12-08 LATEST REVISION DATE	<i>Thomas C. McQuinn</i> APPROVED BY BRIDGE ENGINEER		
		STANDARD DESIGN - 24' ROADWAY, 3 SPAN BRIDGES CONTINUOUS CONCRETE SLAB BRIDGES NOVEMBER, 2006	
MONOLITHIC PIER CAP DETAILS ALL BRIDGES SHEET 2 OF 2		J24-24-06

HALF SECTION NEAR PIER
 SHOWING STIRRUP SPACING AND NUMBER OF PILING
 NOTE: BOTTOM OF CAP ELEVATIONS WILL BE REQUIRED AT THE
 CL OF ROADWAY AND AT EACH EXTERIOR PILE.

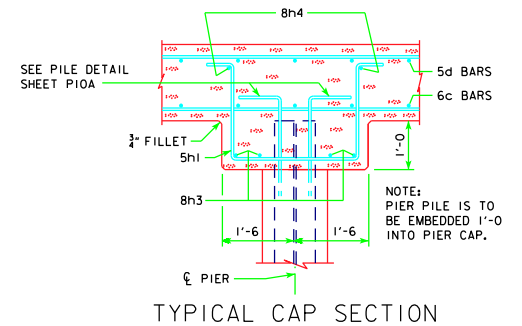
REVISED 12-08 - REVISED PILES REQUIRED FOR 110'-0 BRIDGE.
